ACCESS REPORT

Proposed Boarding House Development
195-197 Sydney Rd, Fairlight

Date
26th November 2020

Reference No.
20281

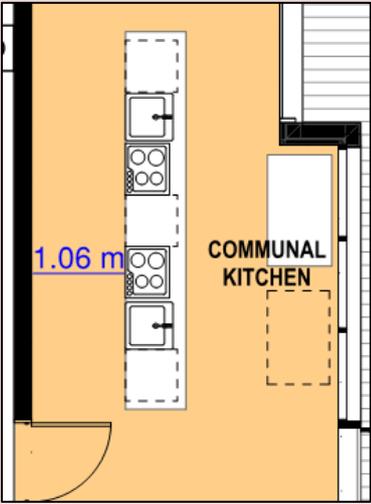
Compliance Status	
	<ul style="list-style-type: none"> - To and within all outdoor and indoor communal areas. - To and within basement level. <p>The design is suitably detailed to comply with AS 1428.1-2009 except for matter/s listed below.</p>
Does not comply	<ol style="list-style-type: none"> 1. Provide a 1550mm space in front of the communal kitchen: <div style="text-align: center;">  </div> 2. Only stair access shall be provided to Building B on Level 5 from the lift. This is in consequence of Council requirement for maximum lift overrun height. A performance solution shall be provided at CC stage to verify suitability of this design outcome. <p>Compliance is readily achievable during construction certificate design phase.</p>

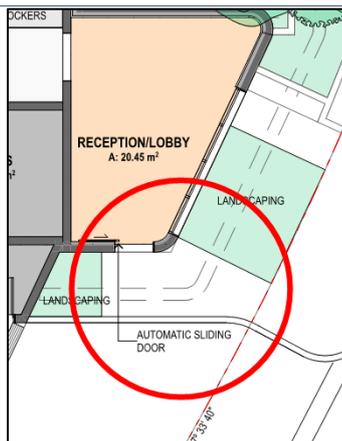
Compliance Status	
Complies	<p>The accessway from the point of entry at the allotment boundary appears to be suitably detailed for compliance with AS 1428.1-2009.</p> <p>Ensure both gradient and crossfall is not steeper than 1:40 and door controls comply with AS 1428.1-2009:</p>

Compliance is readily achievable during construction certificate design phase &/or during construction.

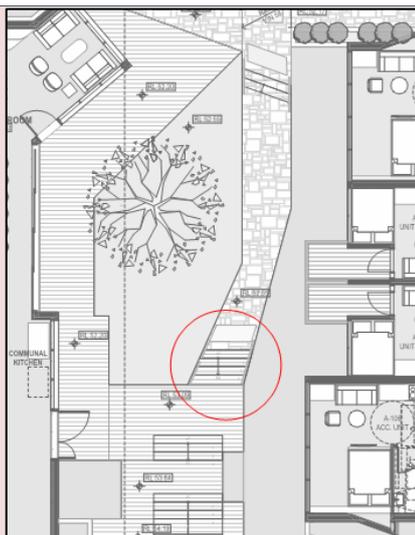
1. All non-fire-isolated stairways (as determined by the BCA consultant / certifier) shall be provided with fixtures & fittings per Clauses 11 & 12 of AS 1428.1-2009.
 2. The fire-isolated stairways are readily capable of compliance with Cl. 11 (f) and (g) of AS 1428.1-2009.
 3. All walkways (1:20 & shallower) shall be provided with fixtures and fittings per Cl. 10 of AS 1428.1-2009.
 4. All ramps (steeper than 1:20) shall be provided with fixtures & fittings per Cl. 10 of AS 1428.1-2009.
- Compliance is readily achievable during construction certificate design phase &/or during construction.

1. Suggest external courtyard stairs are setback from the transverse path of travel to avoid handrail protrusions, in particular we refer to the following stair/s:

2. In various locations, a required 180-degree turning space shall not be provided due to space restriction. A performance solution shall be prepared at CC stage to demonstrate suitability for the lack of a turning space.
3. In a few locations, a reduced 90-degree turning space shall be provided due to space restriction. Either adjust design or a performance solution shall be prepared at CC stage to demonstrate suitability of the reduced 90-degree turning spaces.
4. In various parts of Fire stairs 1 and 2, a 1x tread depth handrail extension shall not be achieved due to limited space. A performance solution shall be prepared at CC stage to demonstrate suitability for the lack of a 1x tread depth extension.

Compliance is readily achievable at construction certificate phase.
